CASE#: MHRB\_2016-0018 DATE FILED: 6/15/2016 OWNER/APPLICANT: COLLIN MAXWELL REQUEST: A Mendocino Historical Review Board Permit request to demolish, reconstruct, and/or construct the Ferro House, garage, tower, fencing, driveway and other structures. Note: Mendocino Town Plan Appendix 1 lists the site as a Category IIa Historic Resource. ENVIRONMENTAL DETERMINATION: A Class 31 Categorical Exemption from the California Environmental Quality Act for restoration of a historical resource following the Secretary of the Interior's Guidelines for Preservation and Restoration of Historic Resources Categorically Exempt LOCATION: 45270 Albion Street, Mendocino (APN: 119-217-06) SUPERVISORIAL DISTRICT: 5 STAFF PLANNER: JULIA ACKER KROG

## MENDOCINO HISTORICAL REVIEW BOARD STAFF REPORT

## FEBRUARY 3, 2020 MHRB\_2016-0018

(N) WOOD DECKING 	
PROPOSED WATERTOWER	USERS.
east property line east property line pollin Maxwell 270 Albion Street endocino, California	
95460	- (E) GATE TO REMAIN
AVEMENT	
ALBION STREET	
PLAN - EXISTING & PROPOSED	DATE: NOVEWBER 18, 2019 SCALE: AS NOTED DRAWN BY: KBQ JOB: WAXWELL SHEET NO: OF 6

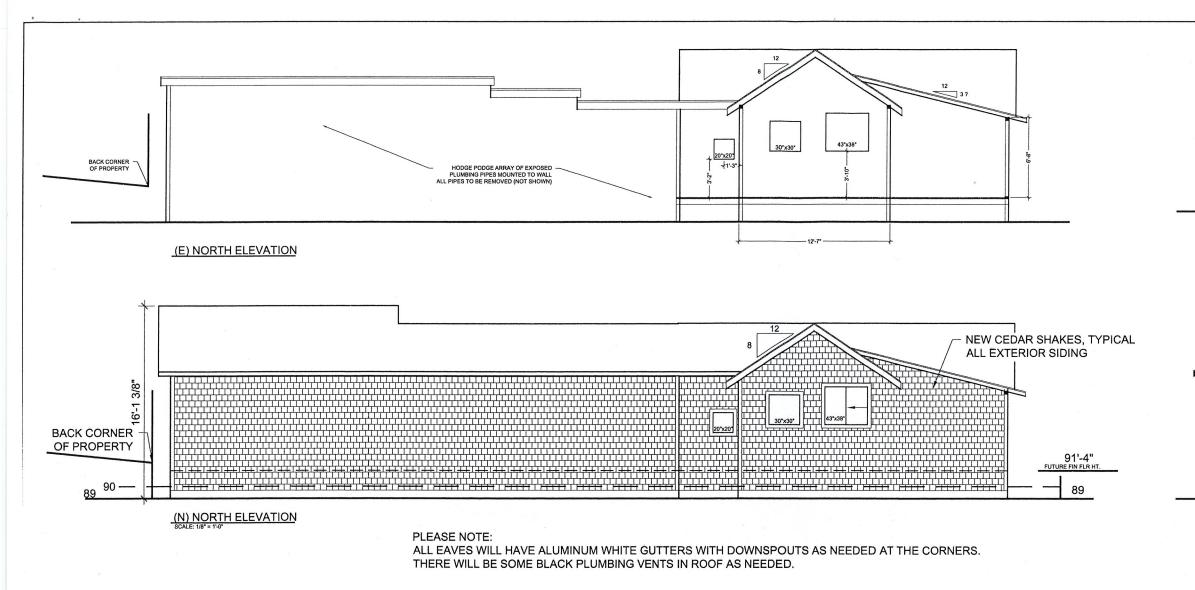
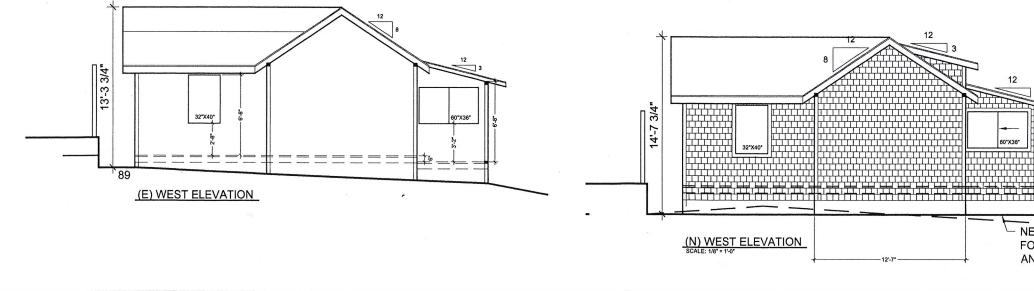
- D. <u>Concrete slab</u> The cement structure located on west side of the property adjacent to property boundary would be removed from the property (See Sheet No. A1 Site Plan Existing and Proposed).
- E. <u>Walkways and patios</u> A brick walkway connected the buildings, forming a courtyard between the cabin, its additions, and the tower (CHRC). West of the tower, the brick has been covered by multiple pours of concrete and gaps in the concrete are deliberately left to allow access to makeshift plumbing fixtures. The existing cement patios would be removed and in their place would largely be new

wooden decking, the walkway from the house to the garage would be replaced and slightly enlarged and a new concrete walkway placed along the eastern property boundary (See Sheet No. A1 Site Plan – Existing and Proposed). The brick and concrete between the house and water tower would be replaced with 840 square feet of new wood decking, which does not count towards lot coverage calculations. Vegetation, existing cement walkways, and various pipes would be removed from the site.

- H. <u>Sewer connection</u> If necessary, the sewer line would be replaced.
- I. <u>Travel Trailer</u> The existing travel trailer is proposed to be removed from the site, as shown on the Site Plan (Sheet A1). Condition 18 is recommended to ensure removal of the travel trailer occurs in a timely fashion.

- 18. Any travel trailer existing on the parcel shall be removed from the site prior to the Final Inspection on the Building Permit for the residence.
- 19. Driveway aprons and curb cuts may require an encroachment permit from MCDOT.

Kelly B. Grimes, Architect	A REMODELED RESIDENCE FOR:			NOTES:
P.O. Box 598 Little River, CA 95456 707-937-2904		COLLIN MAXWELL 45270 Albion street mendocino, ca 95460	A.P. # 119-217-06	SHEET NAME: HOUS

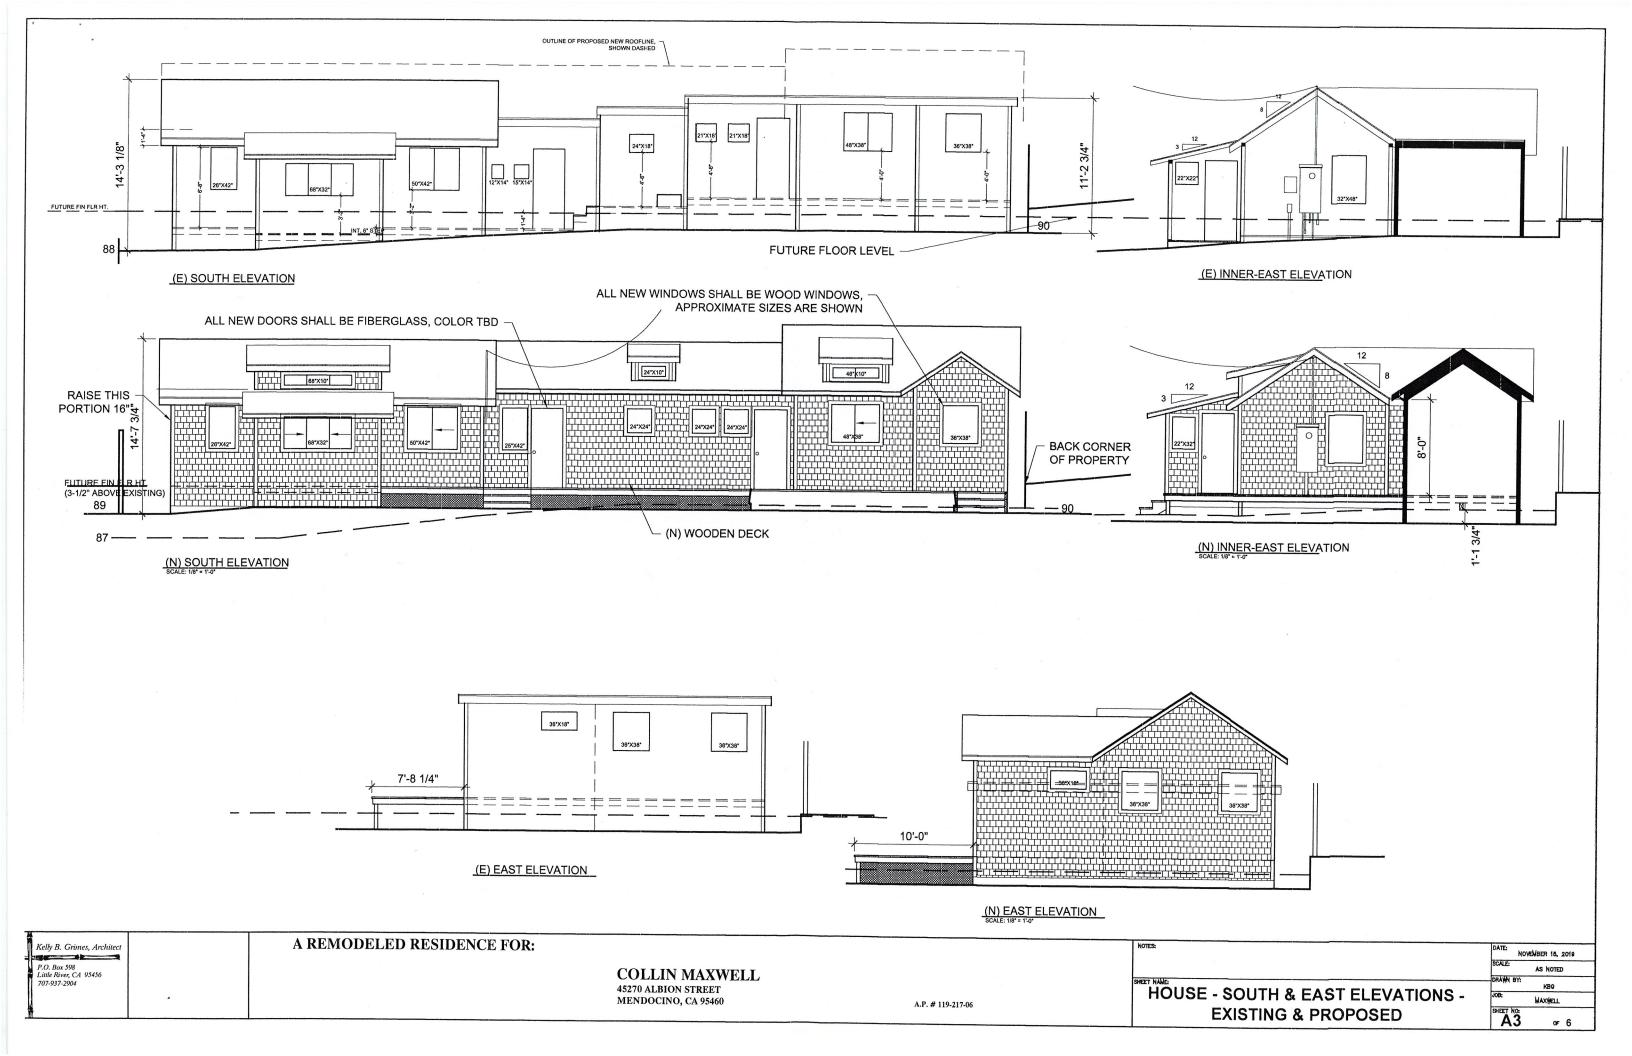
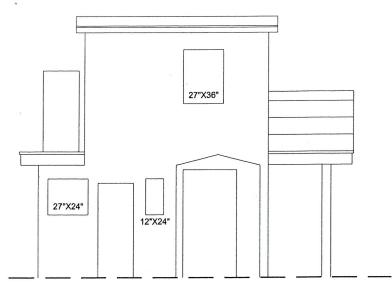
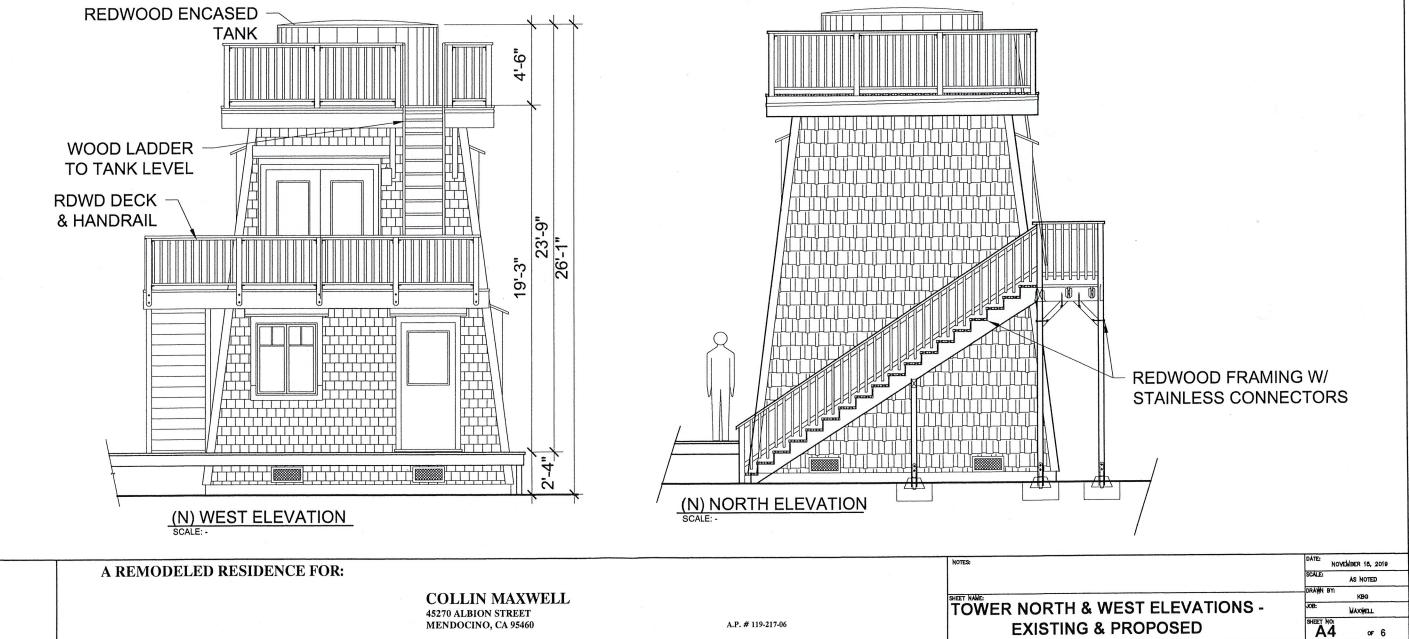
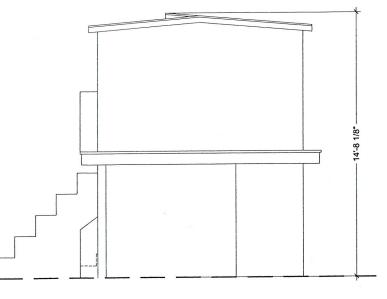
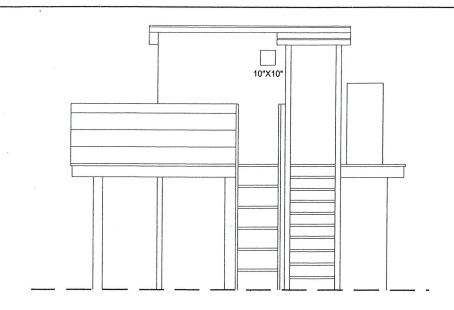
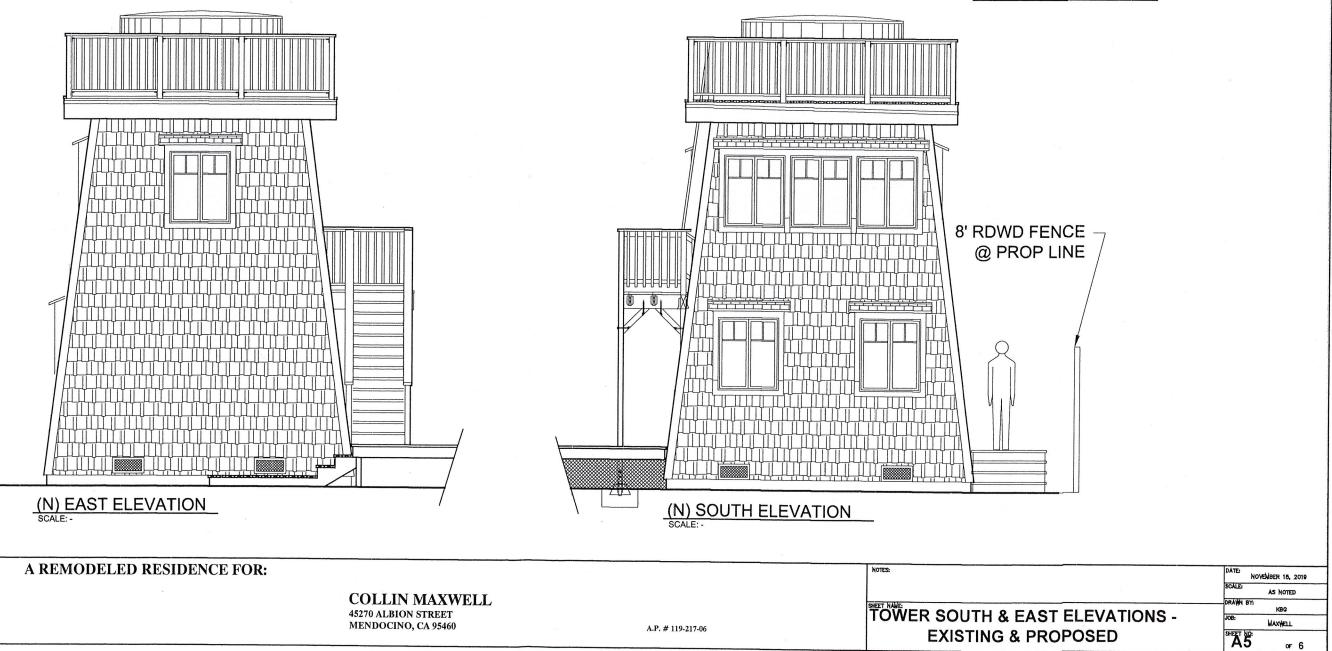
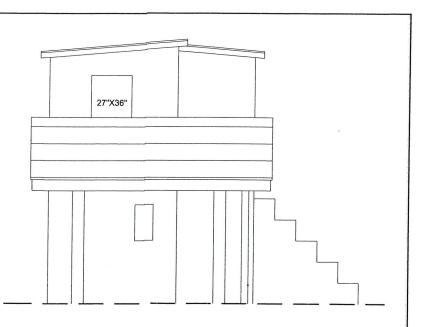
<u>Proposed House Restoration and New Construction</u>. The siding to the house (cabin, mudroom, additions) would be cedar shingles with oil finish to help preserve the material with the pattern shown in Attachment B. Redwood trim would be stained forest green. The cabin, mudroom, and additions would be reconstructed in the existing foot print. The rooflines would be reconstructed with the same 8:12 pitch as shown on the as-built plans, except the circa 1890 addition with flat roofs would be rebuilt with a 8:12 pitched gabled roof running east west. Asphalt shingles would be used throughout. Existing windows would be replaced with wood-frame windows having mostly the same size, style, and shape as those existing. Sliding windows, as shown on the plans, are generally not appropriate

for the historic district as described on Page 8 of the Guidelines; therefore, Staff recommends Condition 14 requiring the proposed slider windows to be changed to double hung, wood framed windows. Windows would be placed within the proposed dormers. Doors would be replaced with stained fiberglass doors, Staff recommends Condition 14 to require the doors to be changed to wood material. All eaves will have aluminum white gutters with downspouts as needed at the corners and there will also be black plumbing vents as needed on the roof. See Sheet No.'s A2 through A3 for existing and proposed elevations of the house.

- 13. The House, Tower, and Garage shall be clad with cedar shingles as shown on the elevations, with the design as shown in Attachment B.
- 14. Window frames shall be made of wood. All proposed slider windows shall be changed to double-hung wood windows. The fiberglass doors shown on the plans shall be changed to wood doors.
